Model: Stella-C1		Date: 9-Jan-02	No.: RB044001
Subject: PS2 Option		Prepared by: K. Ugaeri	
From: Technical Services Dept., GTS Division			
Classification:	<input checked="" type="checkbox"/> Troubleshooting <input type="checkbox"/> Mechanical <input type="checkbox"/> Paper path <input type="checkbox"/> Other (      )	<input type="checkbox"/> Part information <input type="checkbox"/> Electrical <input type="checkbox"/> Transmit/receive	<input checked="" type="checkbox"/> Action required <input type="checkbox"/> Service manual revision <input checked="" type="checkbox"/> Retrofit information

Model: Stella-C1		Date: 19-Feb-02	No.: RB044002
Subject: Caution when installing the DF74		Prepared by: M.Ishihara	
From: Technical Services Dept., GTS Division			
Classification:	<input checked="" type="checkbox"/> Troubleshooting	<input type="checkbox"/> Part information	<input type="checkbox"/> Action required
	<input type="checkbox"/> Mechanical	<input type="checkbox"/> Electrical	<input type="checkbox"/> Service manual revision
	<input type="checkbox"/> Paper path	<input type="checkbox"/> Transmit/receive	<input type="checkbox"/> Retrofit information
	<input type="checkbox"/> Other (

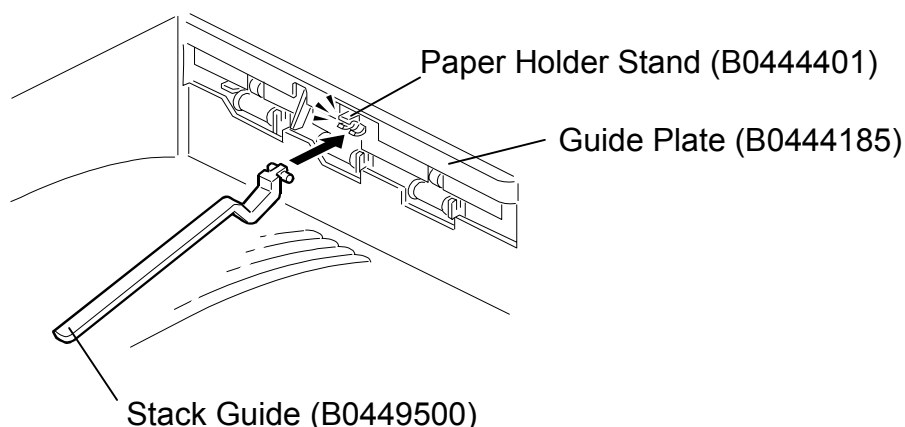
Occasional paper jam at the exit area when using paper that curls easily (e.g. thin paper).

During the copy process, the leading/trailing edges of the paper sometimes curl downward, which can prevent proper stacking and cause a jam.

A Stack Guide (P/N **B0449500**) has been registered as a service part, which will allow the paper to stack properly even if it is curled downward.

**Note:** The Guide is only effective for downward curling. It does not minimize jams when any of the paper edges curl upward.

As shown below, the Stack Guide should be set on the Paper Holder Stand (B0444401), which is attached to the Guide Plate (B0444185) in the paper exit area.

If returning sheets to the paper stack after removal, be sure to place them under the Stack Guide (otherwise, a paper jam will result).

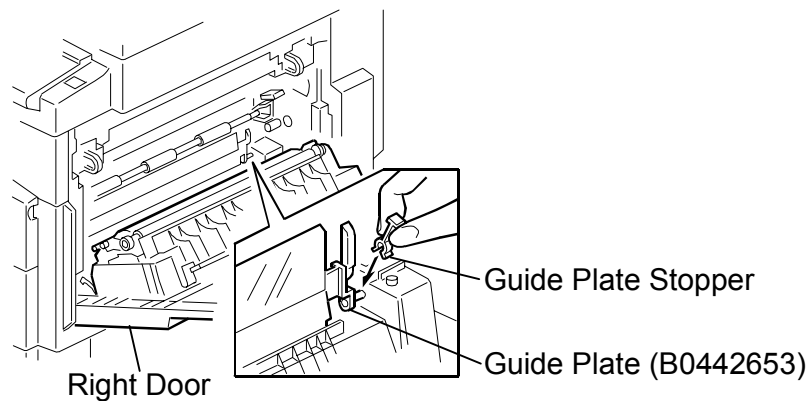
Paper jam

The Paper Feed Guide Plate (B0442653) disconnects from the pivot area.

Attach a Guide Plate Stopper as shown below.

The Guide Plate Stopper was applied to mainframe production from June '02. The cut-in S/N and P/N for the Stopper will be announced as soon as the S/Ns have been confirmed.

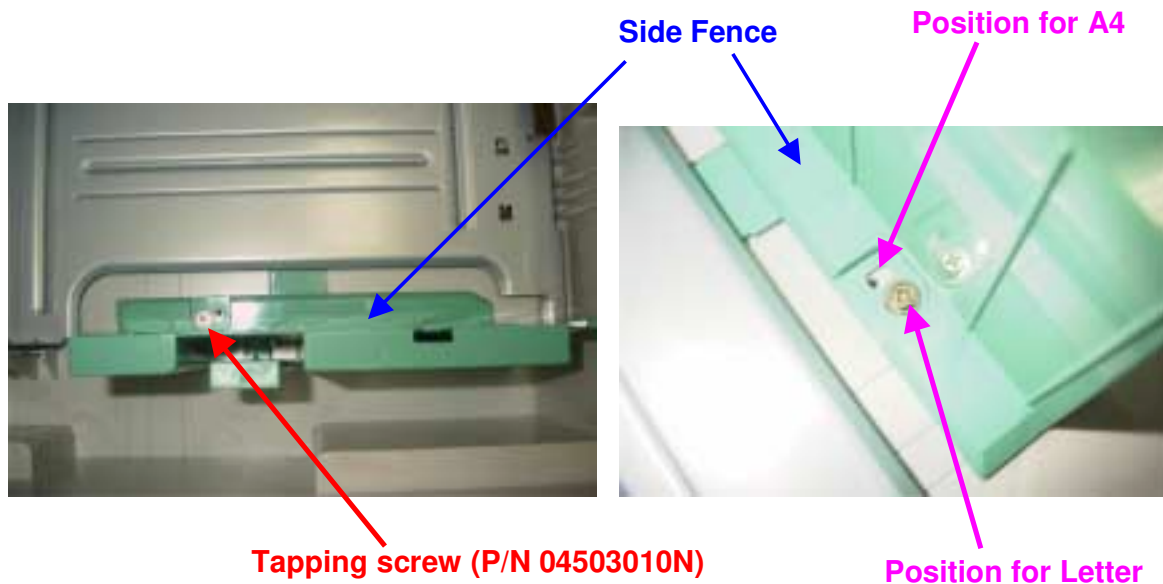
Non-feed jam in the optional paper tray unit.

The side fence can shift inward when the operator loads the paper incorrectly (e.g. not fanning the stack, not placing it in the tray gently), which can then tighten the fence's hold on the paper and make it difficult to feed.

A tapping screw (P/N 04503010N) will be packed together with the optional paper tray unit (B421) for securing the side fence in place at installation.  
Applied from: June 2004 unit production.

After gaining the consent of the customer, please fix the side fence to the base of the cassette using one tapping screw.  
(See the photos on the next page).

## Fixing the Side Fence in Place

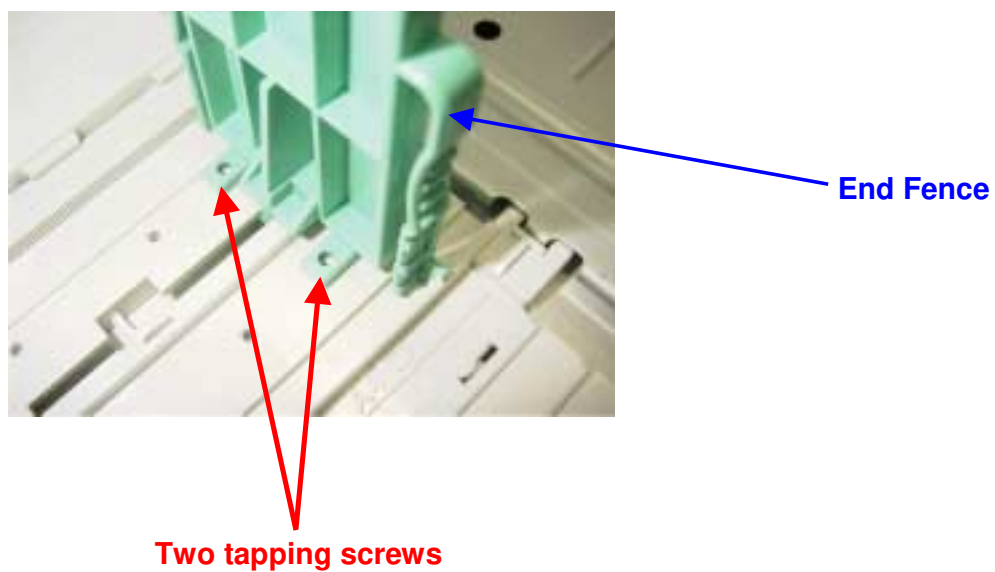
- Depending on the usage conditions of the customer, it may advantageous to fix the end fence in place as well. This requires two tapping screws, which are not included with the tray unit.
- Please inform the customer that once the side fence is secured in place, 1) the paper size cannot be changed (until the next service visit), and 2) moving the fixed fence by force may damage the fence and/or cassette base.
